E.1.a.a -2747 Asquith Street: Development Variance Permit No. 00258 (Oaklands)

Committee of the Whole Report For the Meeting of April 1, 2021

Subject: Development Variance Permit Application No. 00258 for 2747 Asquith Street

ARMITAGE ARCHITECT

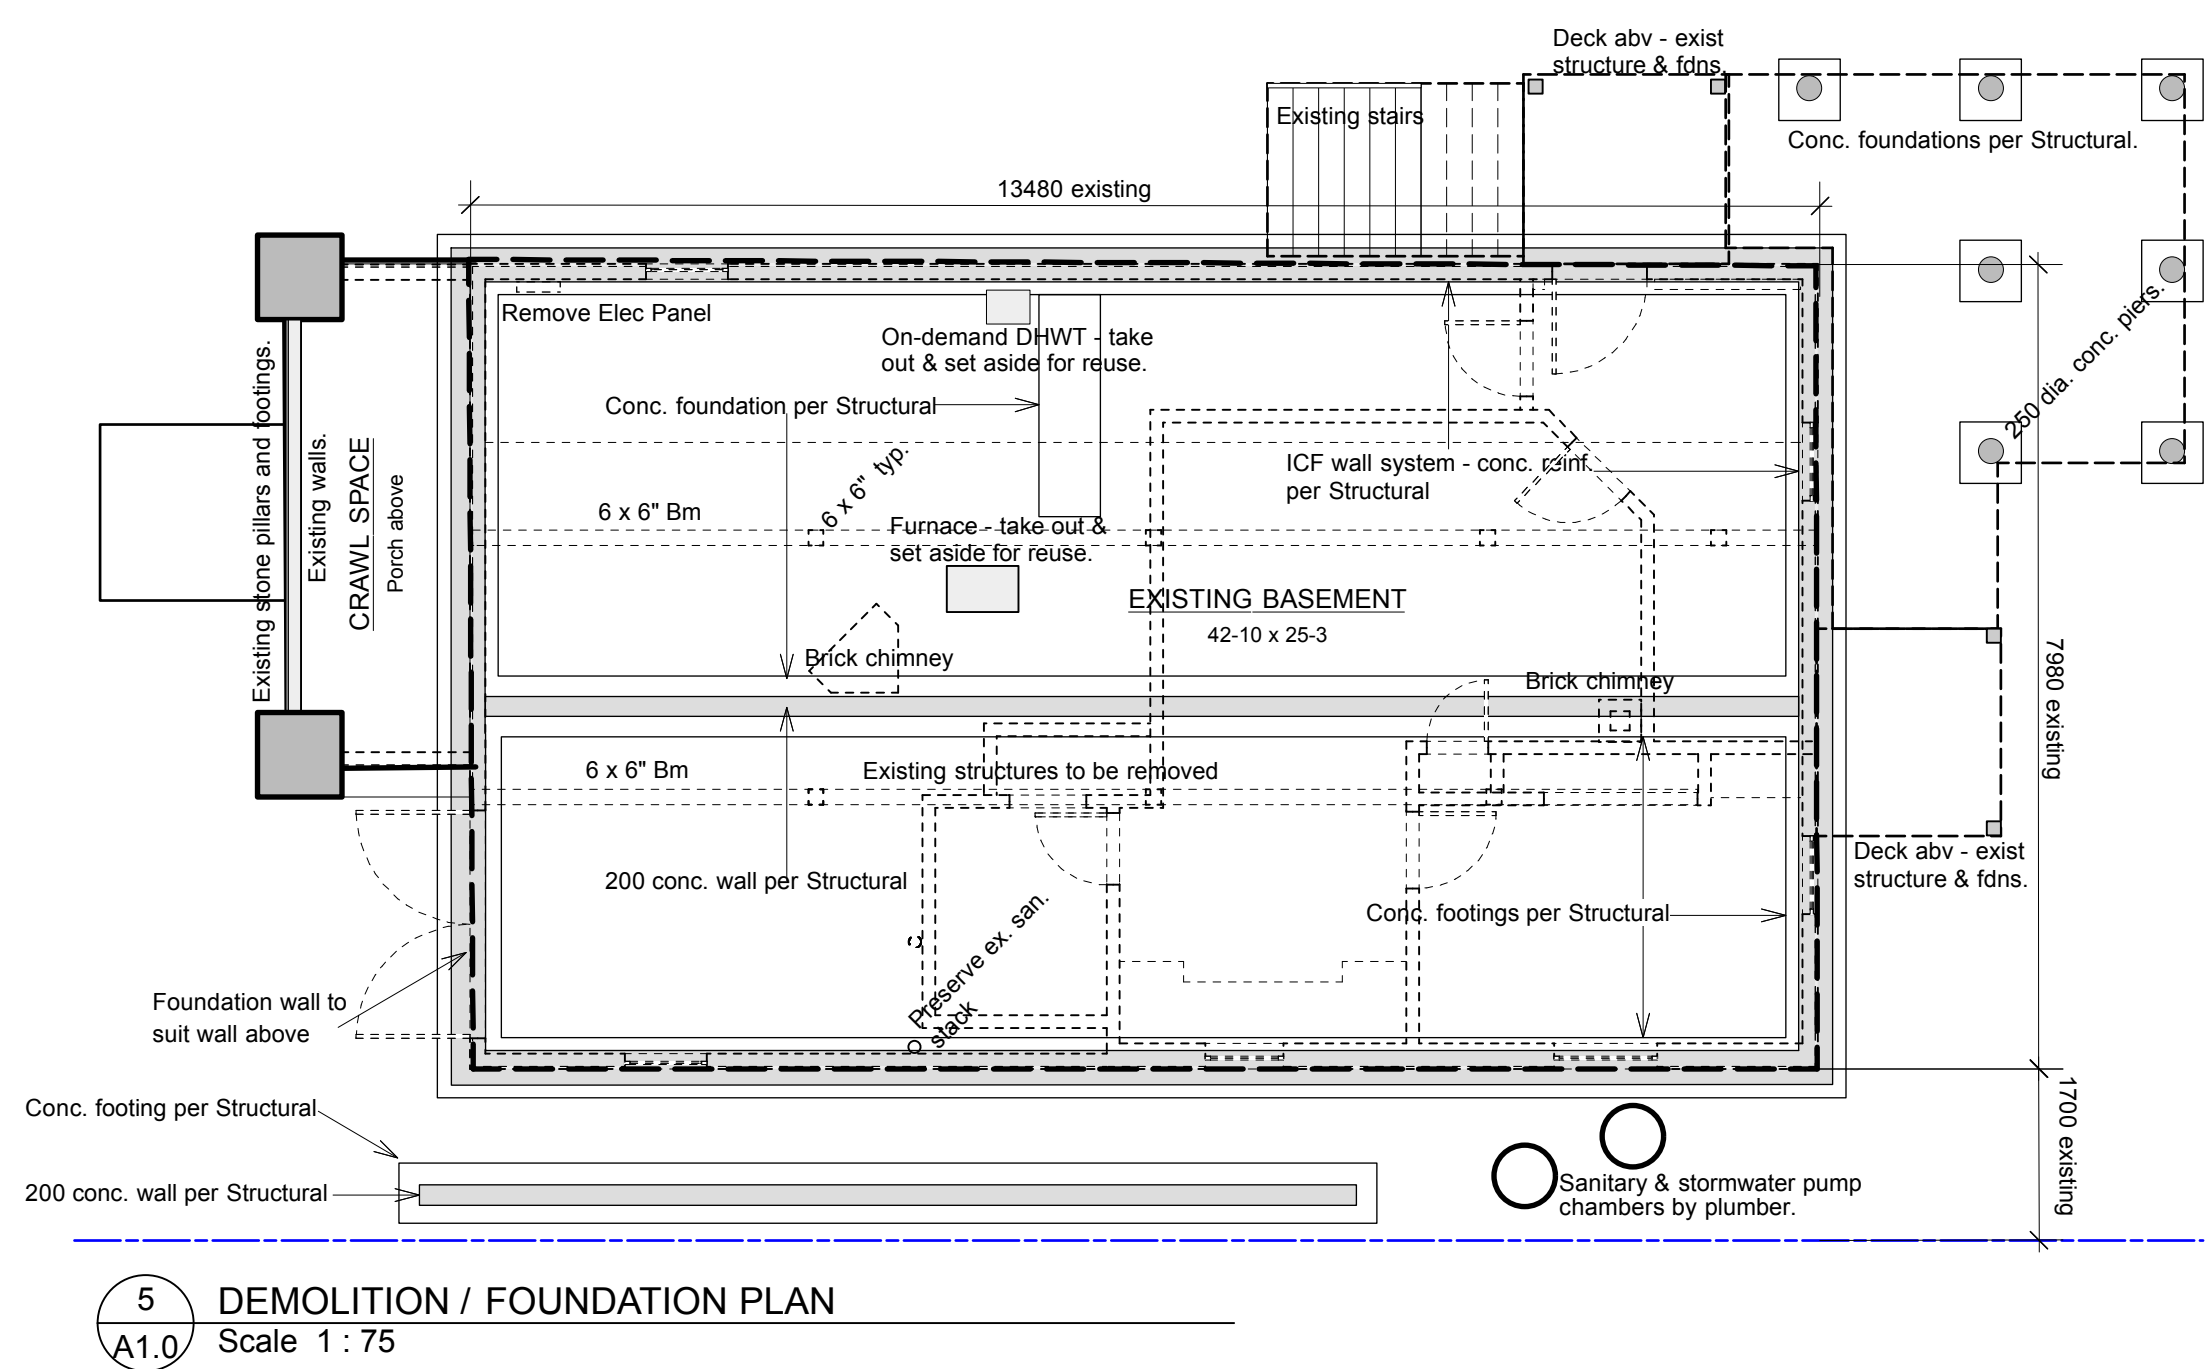
The purpose of this report is to present Council with information, analysis and recommendations for a Development Variance Permit Application for the property located at 2747 Asquith Street. The proposal is to renovate the existing single-family dwelling to create a secondary suite. The proposal meets the required number of parking stalls (one). However, a variance is required to reduce the minimum distance from the parking stall to a street from 1.0m to 0.87m.

- the proposal is consistent with the *Oaklands Neighbourhood Plan* as it maintains the low-scale, family-oriented character of the neighbourhood.
- the variance to reduce the required distance from the parking stall to the street by 0.13m (approximately five inches) is considered supportable since the municipal boulevard provides sufficient buffer to prevent any potential obstruction of the sidewalk.

The existing property operates with a legal non-conforming front yard setback. The proposal meets the required number of parking stalls (one) for a single-family dwelling and secondary suite. The parking stall is located in the front yard as permitted under the bylaw and meets the minimum standards for stall dimensions. However, given the legal non-conforming front yard setback, the proposal cannot meet the required 1.0m distance from a parking stall to a street, without radically altering the exterior façade of the building. The requested variance to reduce this distance to 0.87m is considered supportable since the municipal boulevard provides sufficient buffer to prevent any potential obstruction of the sidewalk.

1. Plans date stamped January 21, 2021.
2. Development meeting all *Zoning Regulation Bylaw* requirements, except for the following variance:
 - i. reduce the minimum distance from the parking stall to a street from 1.0m to 0.87m.
3. The Development Permit lapsing two years from the date of this resolution."

Subject property with driveway and front property line marked.

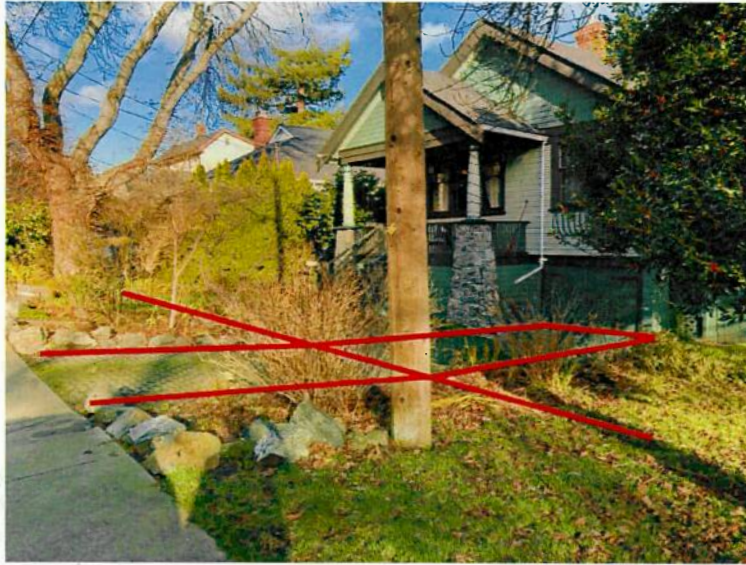
The setback requirement (per Zoning Bylaw, Schedule C) is 6.1m total: 5.1m for the parking space plus an additional 1.0m to a street, commonly referred to as a "landscape strip". The existing setback for this house is 5.97m so it is non-conforming by 130mm (approximately 5") sometimes referred to as "less than a cellphone". On this and neighbouring streets, there is an additional 4.4m of municipal boulevard, between the property line and the back of the sidewalk, that provides a substantial buffer for residential parking. It seems a remote possibility that the City might one day choose to widen this street to such an extent that the length of this driveway would ever become an issue physically or practically. Also, the concept of the 1.0m "landscape strip" is more appropriately applied to "hammerhead" driveway configurations and large commercial parking lots, whereas it is somewhat moot in this case being an essential part of the driveway itself.

To bring the house into conformance would not be impossible but would require cutting back half of the front face of the house. This would require some structural contortions and would compromise the integrity of its appearance and structure. Similarly, a conforming "hammerhead" driveway configuration is theoretically possible but would result in paving almost the entire front yard. This would be out of step with the form and character of the streetscape and would potentially compromise a municipal street tree. Either solution would impose a degree of hardship without achieving any community benefit.
